BMP NUMBER: PC234

**James City County Environmental Division
Stormwater Management/BMP Record Drawing &
Construction Certification Review
Tracking Form**

Project Name: Zion Baptist Church Expansion
 County Plan No.: SP-036-06
 Stormwater Management Facility: Level Spreaders
 BMP Phase #: I II III
 Information Package Received. Date/By: N/A
 Completeness Check:
 Record Drawing Date/By: N/A
 Construction Certification Date/By: N/A
 RD/CC Standard Forms (Required for all BMPs after Feb 1st 2001Only)
 Insp/Maint Agreement # / Date: 215107
 BMP Maintenance Plan Location: Sheet C5
 Other: _____
 Standard E&SC Note on Approved Plan Requiring RD/CC or County comment in plan review
 Yes No Location: _____
 Assign County BMP ID Code #: Code: PC235 & PC234
 Preliminary Input/Log into Division's "As-Built Tracking Log"
 Add Location to GIS Map. Obtain basic site information (GPIN, Owner, Address, etc.)
 Preliminary Log into Access Database (BMP ID #, Plan No., GPIN, Project Name, etc.)
 Active Project File Review (correspondence, H&H, design computations, etc.)
 Initial As-Built File setup (File label, folder, copy plan/details/design information, etc.)

Project Name: ZION BAPTIST SITE IMPRO

Layout and Materials Plan

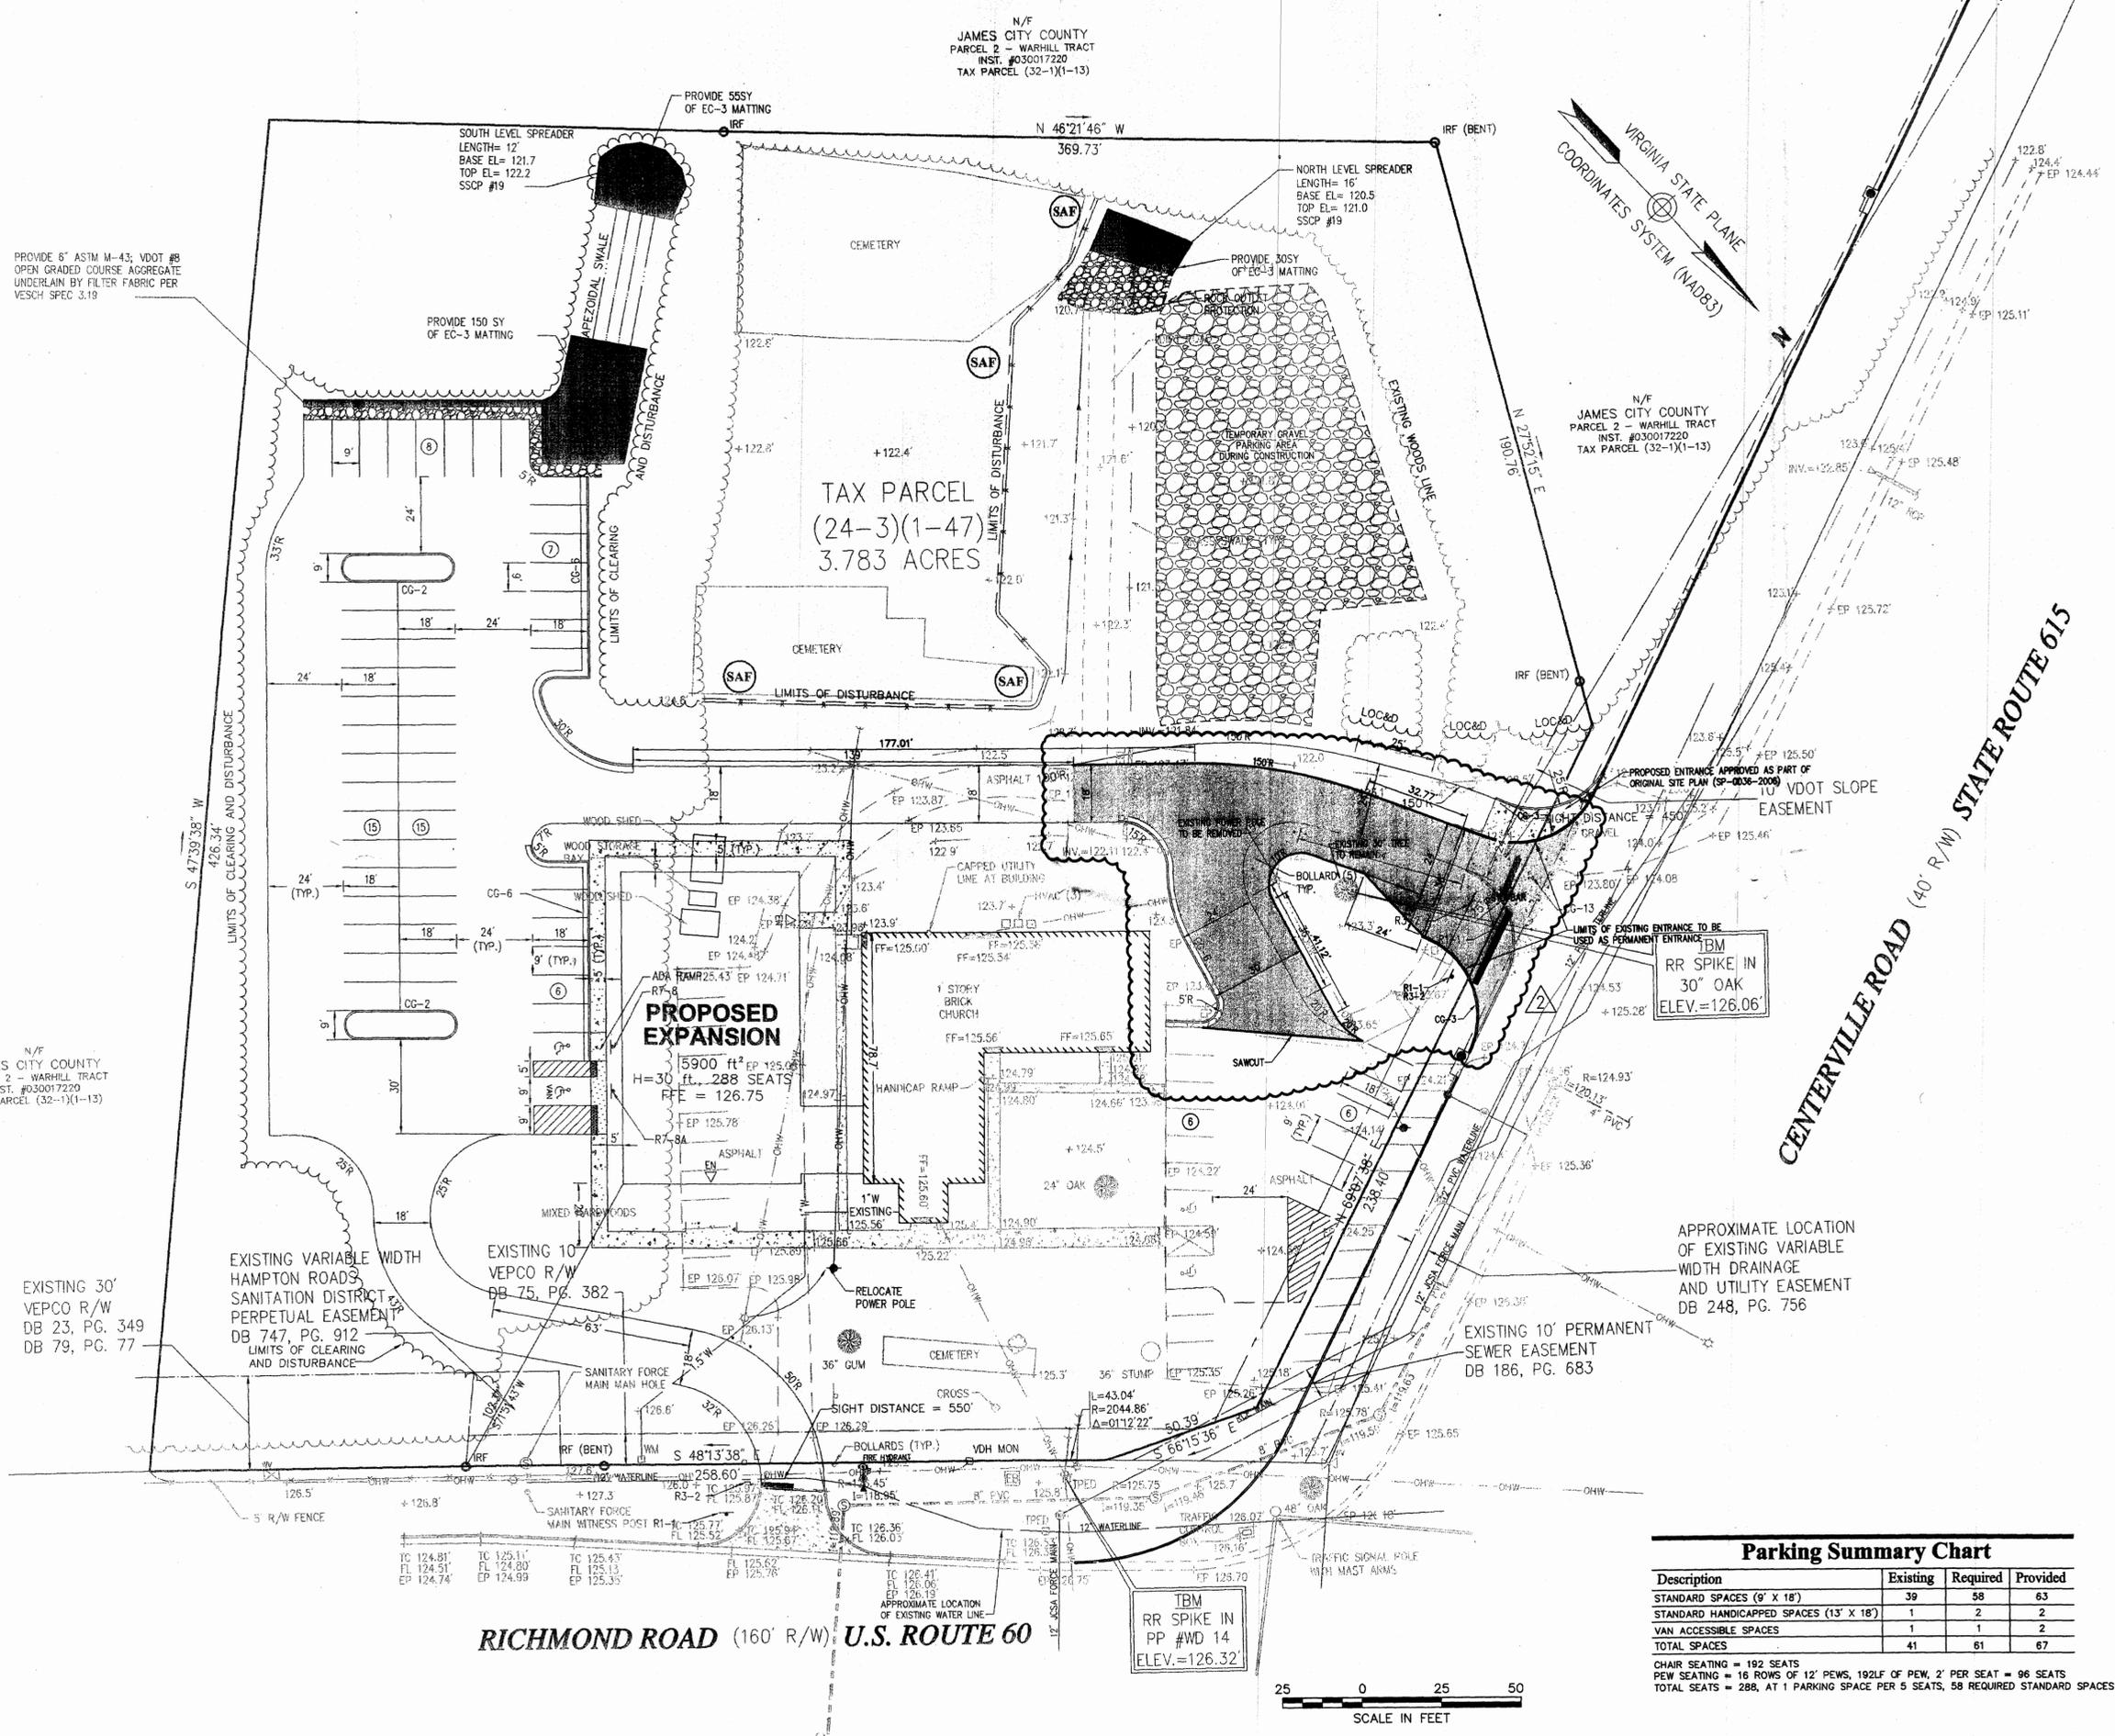
3. ✓ Site Tabulation. Move the site statistics table from Sheet C-5 onto the cover sheet. In one central area, show site area, proposed impervious cover, percent impervious cover (new site) and a disturbed area estimate for the project on the cover sheet. It must be demonstrated that the site imperviousness does not exceed 60 percent. *32% < 60%, cover*

19. ✓ E&SC Plan. The area situated to the northwest of the new parking area (ie. parking area to the south of the new building expansion) is proposed to be a temporary sediment trap during construction, and then a graded trapezoidal swale and level spreader system following stabilization of the site. Once the trap is removed and the system converted to a swale-level spreader, it will be necessary to provide at least one temporary rock check dam within the swale, until the swale itself is stabilized. Show and label the "temporary check dam" on Sheet C-5. *Sheet C-5*

27. SSC. Special Stormwater Criteria credit cannot be given to SSCP # 8 (level spreaders) as shown in the matrix on Sheet C-5 as the level spreaders are being used to address basic stormwater quantity control (MS-19) requirements for the site. SSCP cannot be used to address traditional stormwater management criteria and the SSC criteria; therefore measure from the SSCP menu must be chosen. (Note: Refer to the top of page 5 of the SSC criteria paper for more information. Also, once addressed the fourth paragraph on the first page of the stormwater narrative must be revised See above related comments to the gravel diaphragm and use of EC-3 TRM matting as it pertains to SSC.)

3. Site Tabulation. Move the site statistics table from Sheet C-5 onto the cover sheet. In one central area, show site area, proposed impervious cover, percent impervious cover (new site) and a disturbed area estimate for the project on the cover sheet. It must be demonstrated that the site imperviousness does not exceed 60 percent.

19. E&SC Plan. The area situated to the northwest of the new parking area (ie. parking area to the south of the new building expansion) is proposed to be a temporary sediment trap during construction, and then a graded trapezoidal swale and level spreader system following stabilization of the site. Once the trap is removed and the system converted to a swale-level spreader, it will be necessary to provide at least one temporary rock check dam within the swale, until the swale itself is stabilized. Show and label the "temporary check dam" on Sheet C-5.

27. SSC. Special Stormwater Criteria credit cannot be given to SSCP # 8 (level spreaders) as shown in the matrix on Sheet C-5 as the level spreaders are being used to address basic stormwater quantity control (MS-19) requirements for the site. SSCP cannot be used to address traditional stormwater management criteria and the SSC criteria; therefore measure from the SSCP menu must be chosen. *(Note: Refer to the top of page 5 of the SSC criteria paper for more information. Also, once addressed the fourth paragraph on the first page of the stormwater narrative must be revised See above related comments to the gravel diaphragm and use of EC-3 TRM matting as it pertains to SSC.)*

**LEVEL SPREADER
CROSS SECTION**

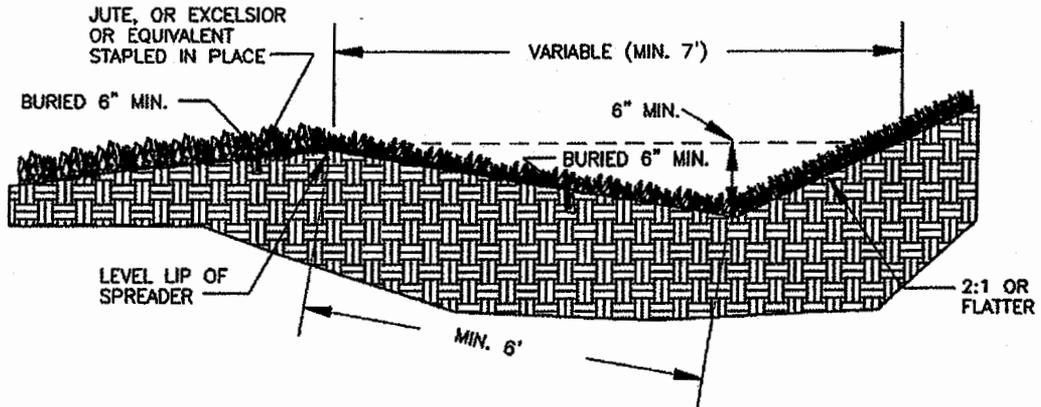
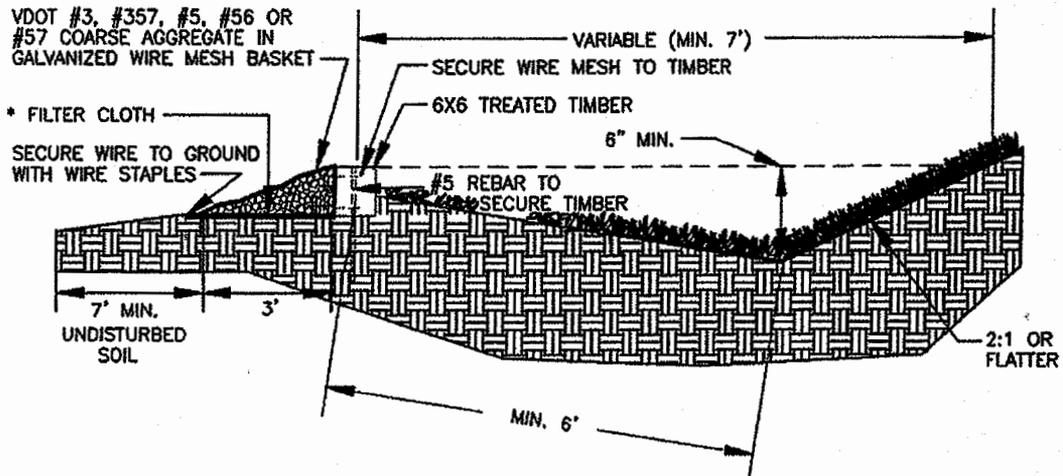
24. ✓ Level Spreaders. As the two proposed level spreaders are permanent not temporary features a BMP maintenance plan is required. The maintenance plan must be provided within the plan set. Refer to Minimum Standard & Spec. 3.21 of the VESCH for information about maintenance of level spreaders. Ensure the maintenance plan references Minimum Standard & Spec. 3.21. sheet C-5

- Response to Comm # 25 says pea-gravel diaphragm detail provided on sheet C-11. Not found.

25. A detail of the gravel diaphragm is provided on Sheet C-11 and is based upon the Virginia Stormwater Management Handbook detail for a pea gravel diaphragm.
26. To dissipate energy from the swale and prevent erosion around the level spreader, rip rap outlet protection is provided.
27. Comment noted. SSC criteria is met with other proposed measures.
